City of Portland, Maine - Building or Use Permit Application

Permit No: 07-0242	Issue Date:	CBL: 174 A013001
-----------------------	-------------	---------------------

Past Use: The Inn at Cedars-	Proposed Use: The Inn at Cedars - Addition to the Cedars for Assisted living facility	Permit Fee: \$48,745.00	Cost of Work: \$4,864,522.00	CEO District: 4	R-5-100 strip along ocean
		FIRE DEPT: <input checked="" type="checkbox"/> Approved <input type="checkbox"/> Denied See conditions	INSPECTION: Use Group: I-1 Type: 5A SEE CONDITIONS 6/3/07

4/2/2007-ldobson: I have commenced the review of the above project and have the following questions/comments:

TITLE: Campus Egress Plan		Ref. Drwg. Survey
THE INN AT CEDARS PORTLAND, ME	DATE: 04/11/2001	TSOMIDES ASSOCIATES Architects/Planners 389 Elliot St. Newton Upper Falls, MA 02464 (617)969-4774 (617)969-4793 Fa
	SCALE: 1" = 100'	
	DRAWING #: ATTACHMENT B-1

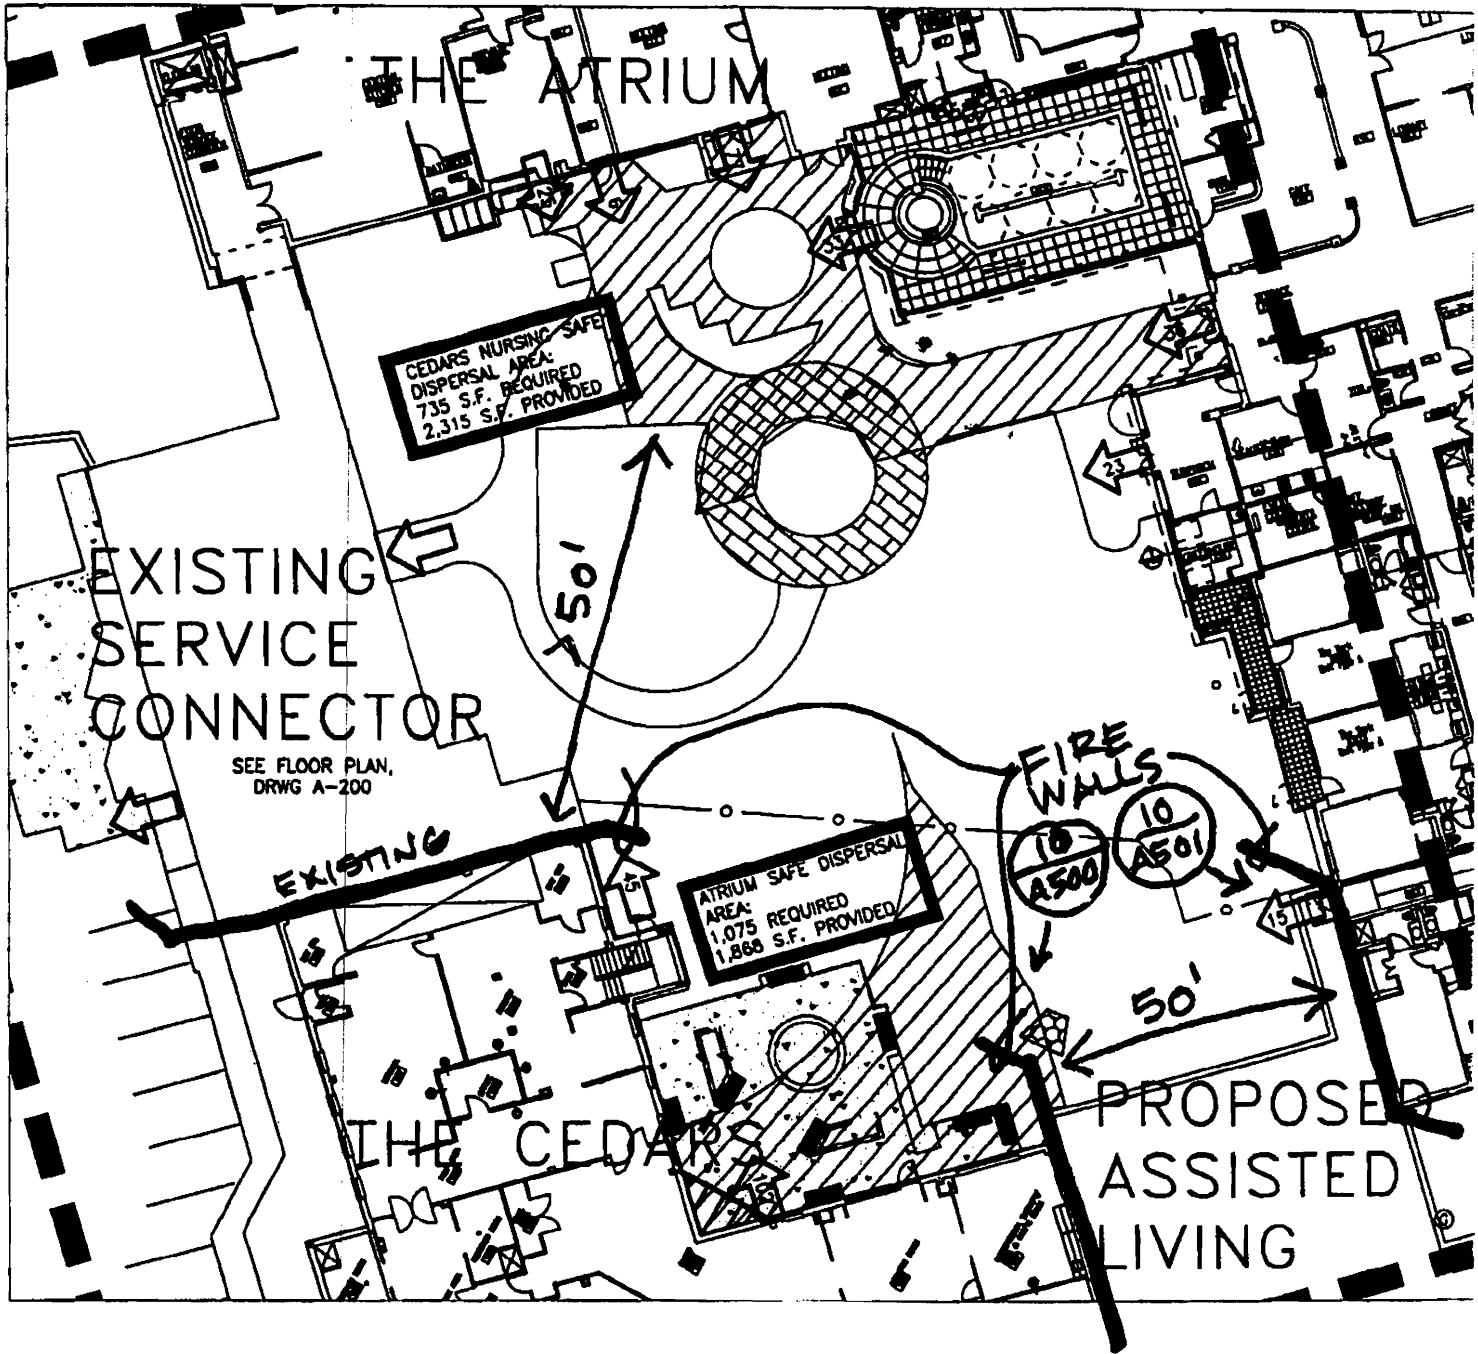
- 2) CRITICAL ISSUE Egress courts/ egress access to a public way-- We had reviewed this concept in the recent past and had difficulty establishing compliance with section 1023.5 and 6 for the addition and the existing building. Please provide a life safety plan for the entire complex that establishes compliance with chapter 10 of the IBC and the NFPA codes.

5/9/2007-ldobson: I've discussed the courtyard issue with Captain Cass and we both would like a floor plan (life safety plan) of the entire facility that will show all egress components both existing and proposed.

Please see attached sketches, **Attachment B:** Campus Egress Plan and Courtyard Egress Plan, 4-11-2007, 2 pages for demonstration of compliance with provisions of the above exception.

TITLE: Courtyard Egress Plan		Ref. Drwg. Survey
CEDARS A.L.F. PORTLAND, ME	DATE: 04/11/2007	TSOMIDES ASSOCIATES Architects/Planners 389 Elliot St. Newton Upper Falls, MA 02464 (617)969-4774 (617)969-4793 Fax
	SCALE: 1" = 30'	
	DRAWING #: ATTACHMENT B-2

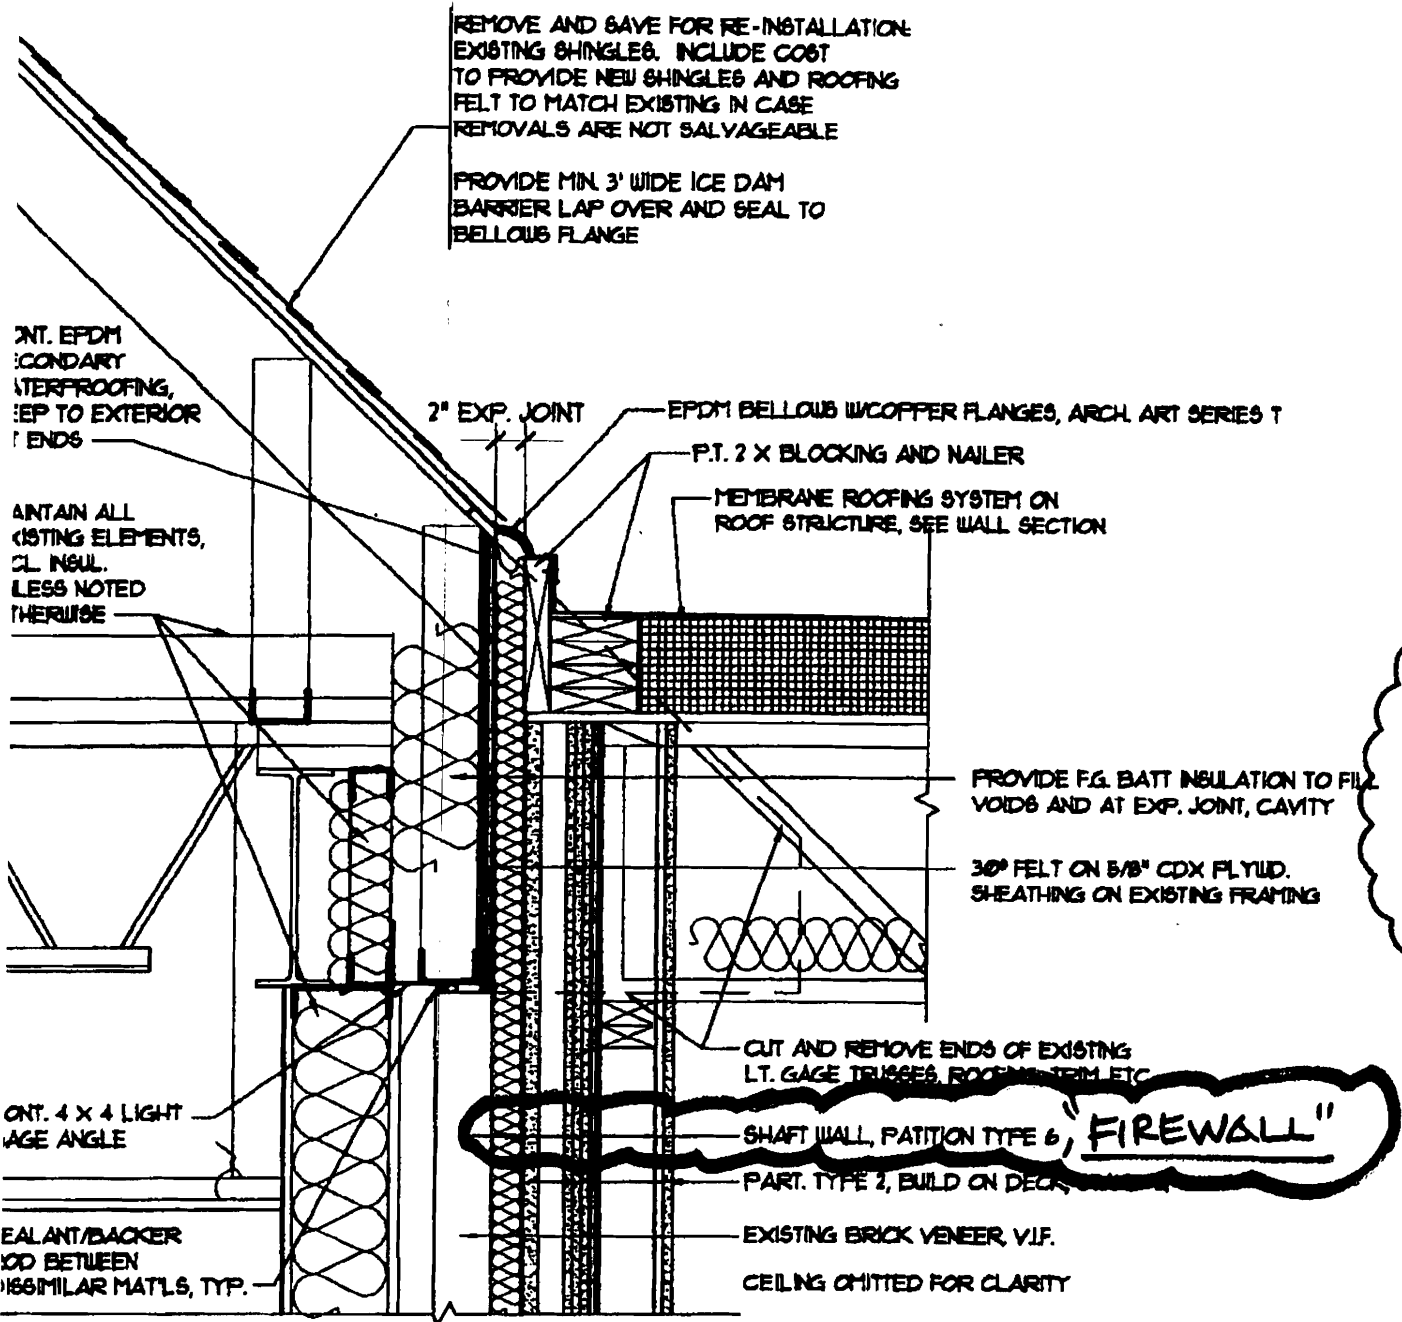
Pursuant to our conversation this morning, please see attached sketches, marked up to further clarify the design intent and methods of satisfying code requirements. Please note that attachment B-2 indicates safe dispersal areas, with 5 s.f. per person, for the existing Atrium and Cedars buildings, 50' away from each building. The proposed assisted living facility does not egress into the courtyard.

TITLE: Campus Egress Plan		Ref. Drwg. Survey
THE INN AT CEDARS PORTLAND, ME	DATE: 04/11/2001	TSOMIDES ASSOCIATES Architects/Planners 389 Elliot St. Newton Upper Falls, MA 02464 (617)969-4774 (617)969-4793 Fax
	SCALE: 1" = 100'	
	DRAWING #: ATTACHMENT B-1

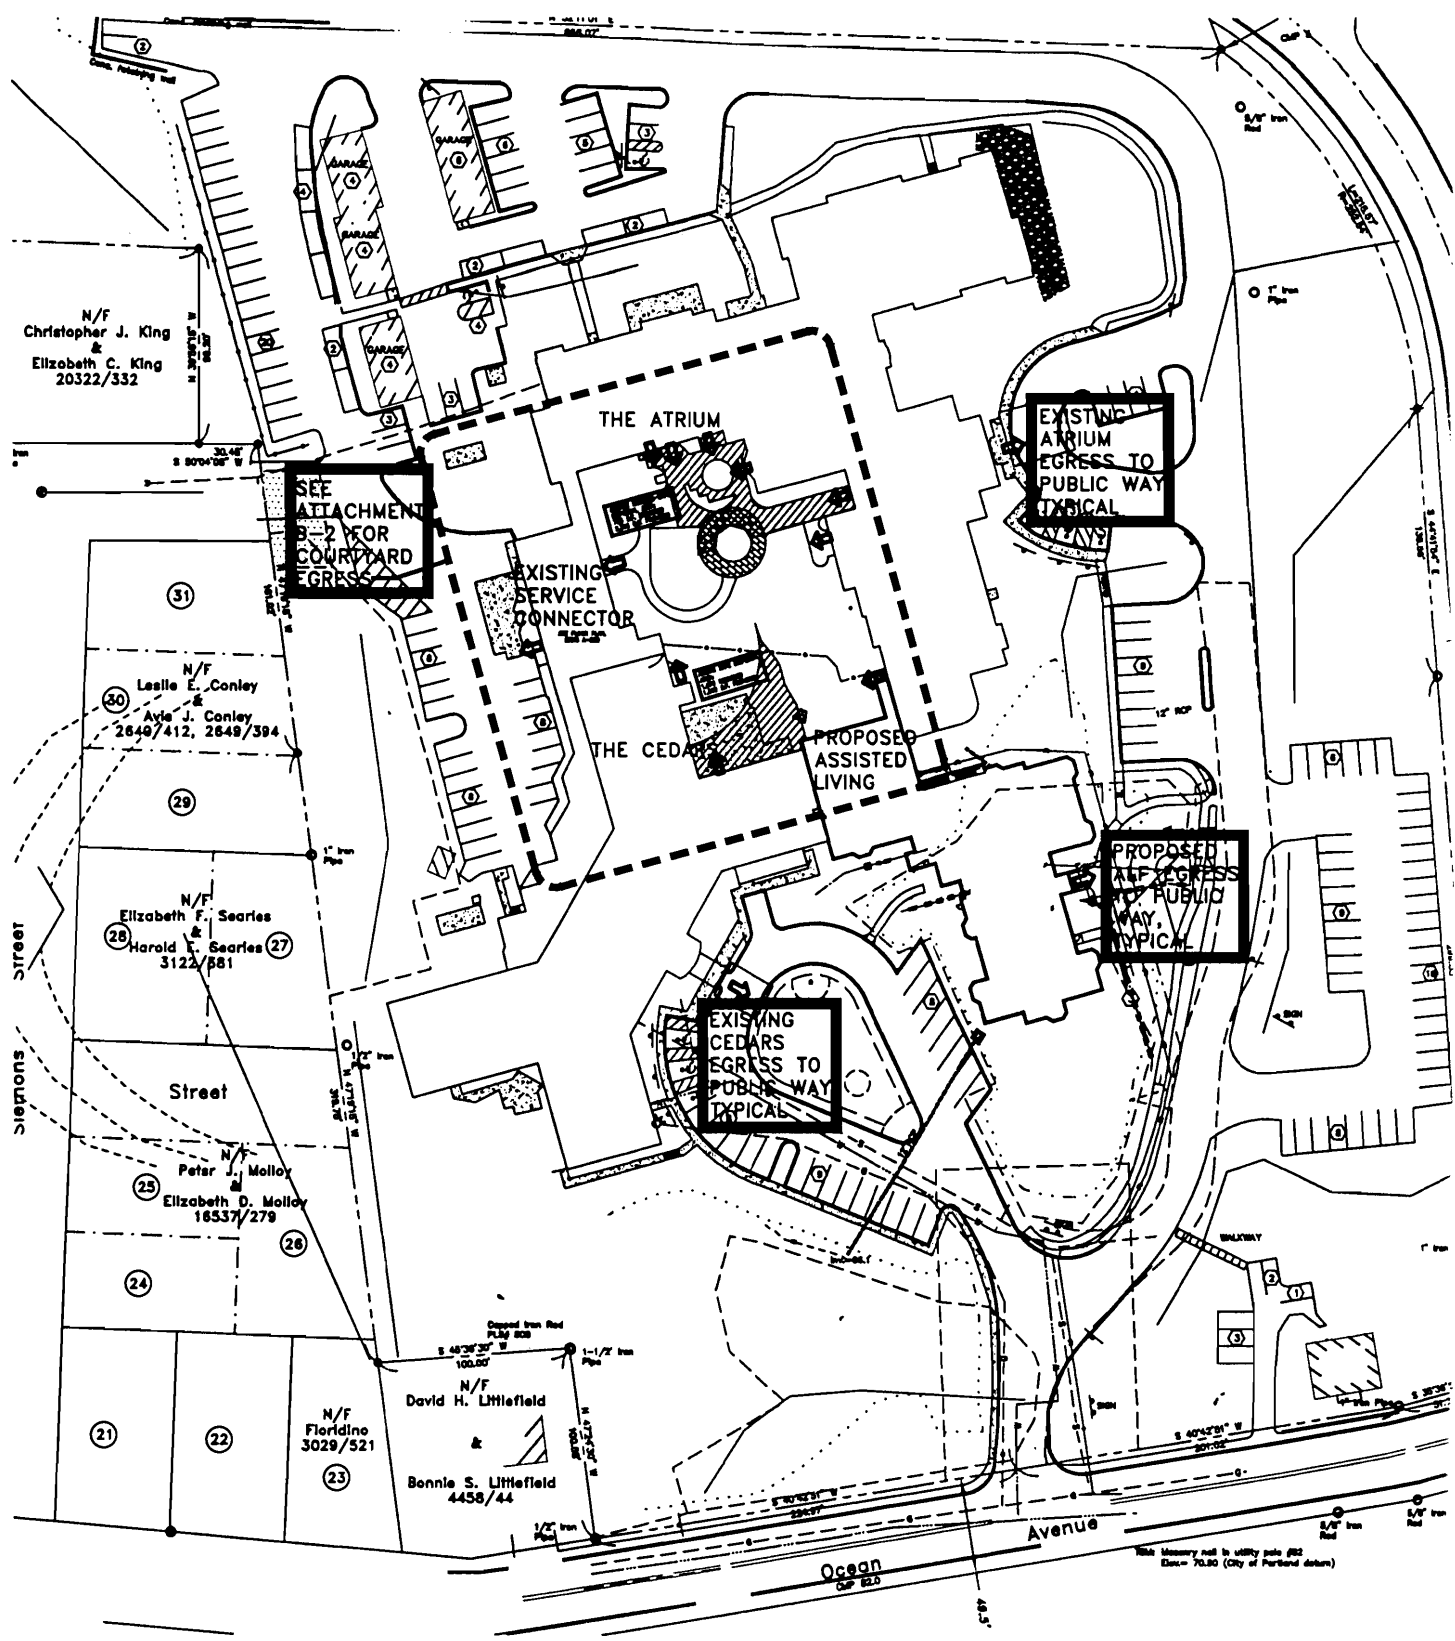
- 2) CRITICAL ISSUE Egress courts/ egress access to a public way-- We had reviewed this concept in the recent past and had difficulty establishing compliance with section 1023.5 and 6 for the addition and the existing building. Please provide a life safety plan for the entire complex that establishes compliance with chapter 10 of the IBC and the NFPA codes.

ATTACHMENT D

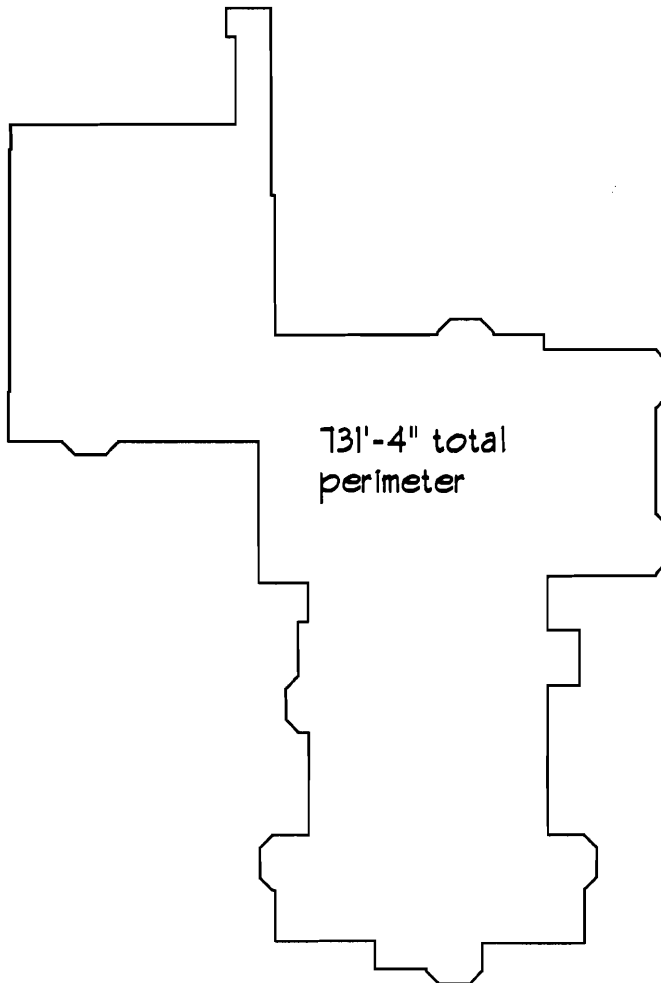
- 3) Please provide an area assessment that establishes compliance with section 503 of the IBC. Because you have chosen an NFPA 13R system, you are not allowed to use the sprinkler area bonus contemplated in section 506.3. This would be available only if you install a full NFPA 13 system.

Area Mod. Frontage Increase, see attached plan and calculations dated 4-3-07, **Attachment D**, 1 page

$2,824 + 10,500 = 13,324 \text{ s.f. / floor allowable with modification}$

DRAFTSTOPPING/DETAIL
INN AT CEDARS
5-24-07
TAAP
DETAIL 1 1/2" = 1'-0"
PLAN 1/32" = 1'-0"

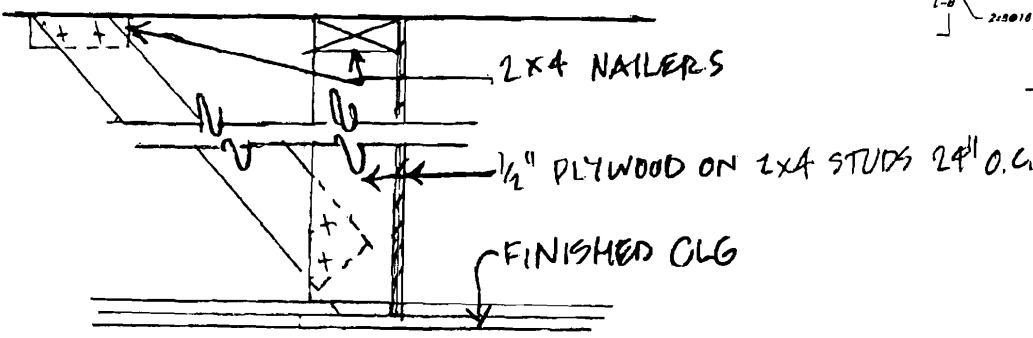
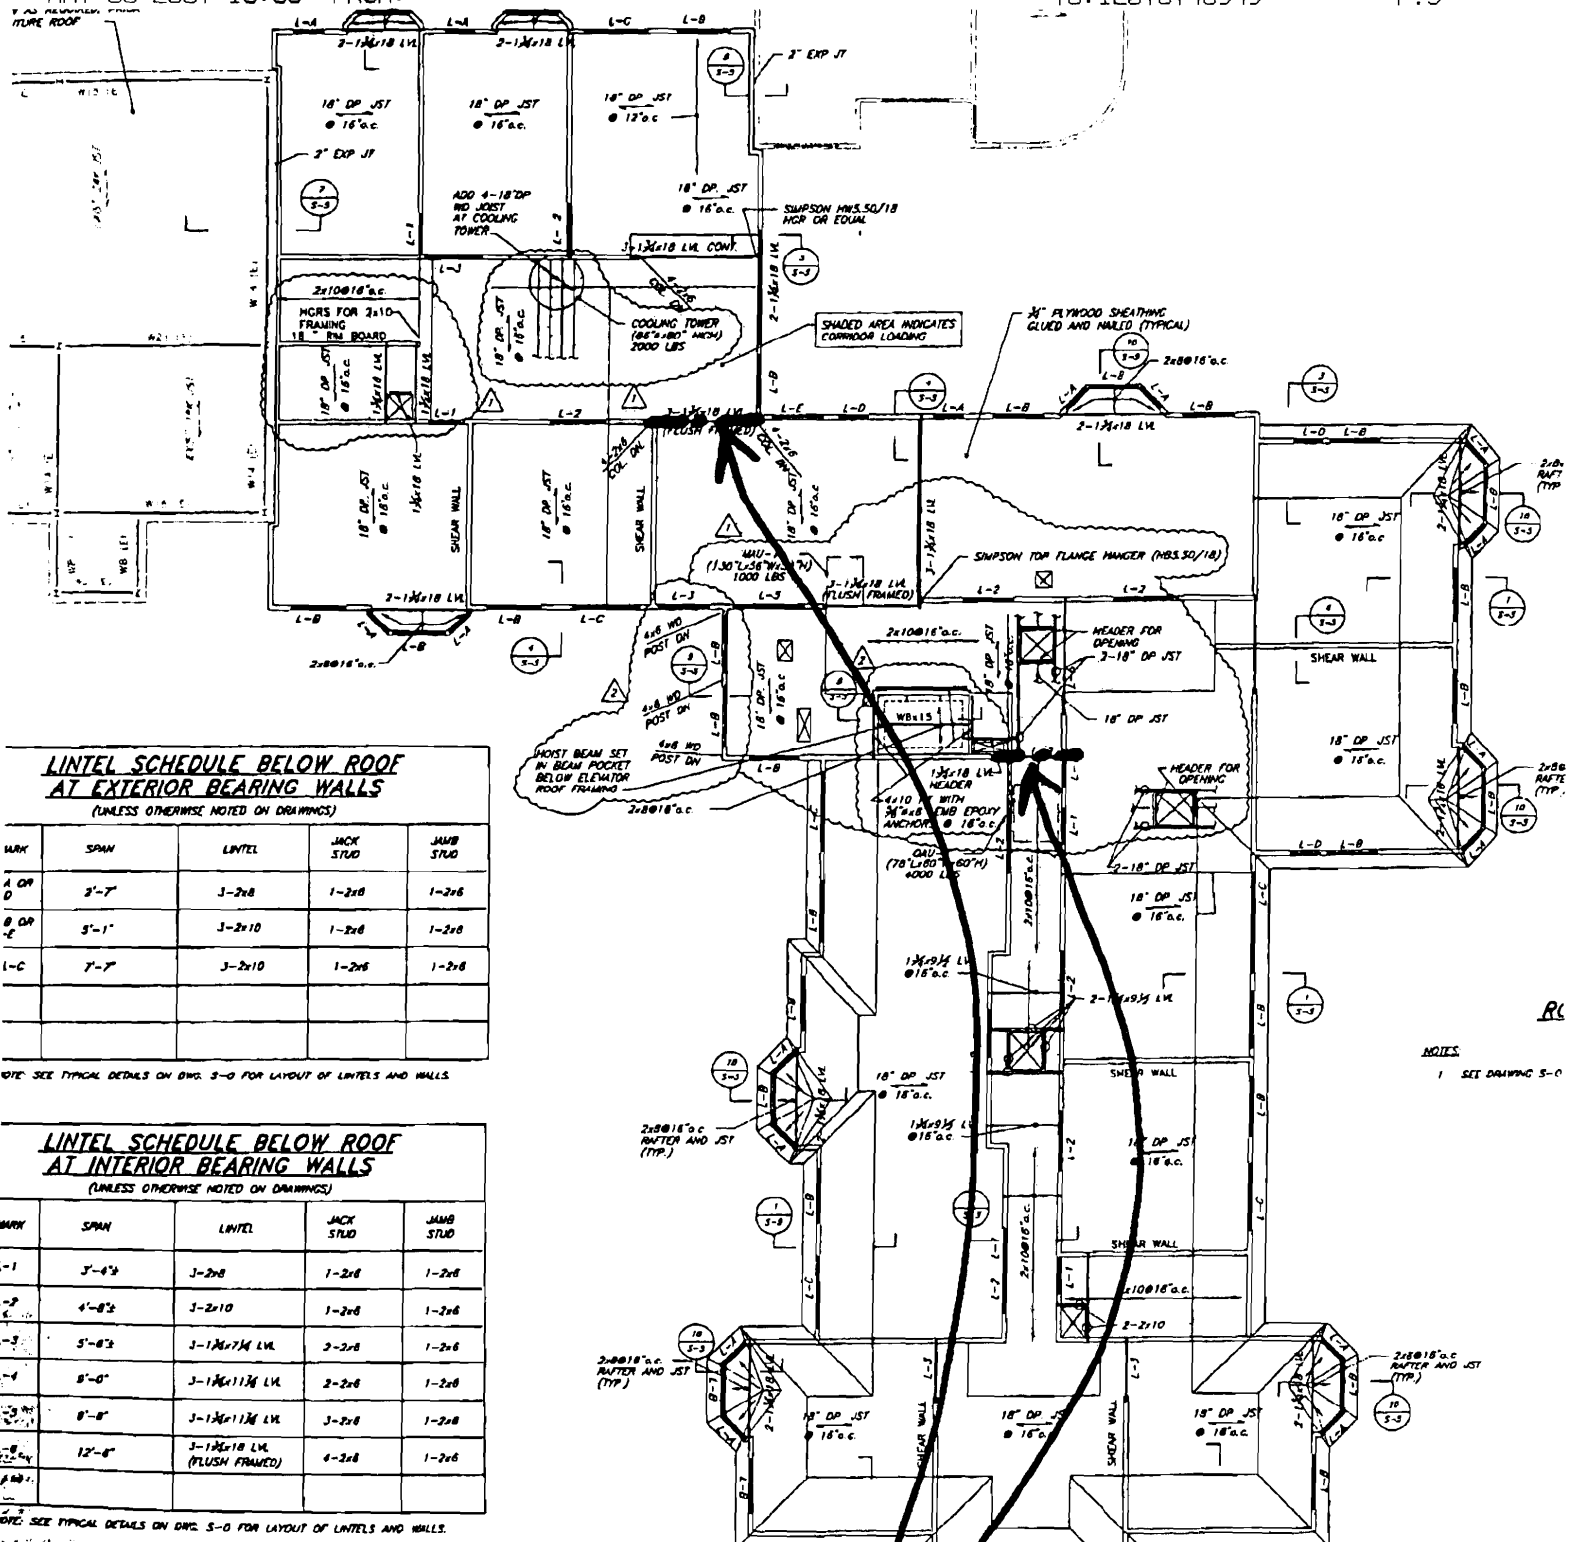
- d. Please provide a "COMCheck" report that establishes compliance with the 2003 International Energy Conservation Code:
Please see attached COMcheck Software "Envelope Compliance Certificate"
- e. From previous correspondence regarding smoke dampers required at ducts penetrating corridor enclosures, and per your indication that our suggested backdraft dampers could not be used as a substitute, we will require that the Contractor install smoke dampers at these locations.

Please see attached sketches for plan locations and detail of draftstopping.

DRAFTSTOPPING
DEMISING WALLS,
CORRIDOR WALLS
EXTEND TO
DECK;
ADDITIONAL
LOCATIONS
L1,000 S.F.
AREAS.
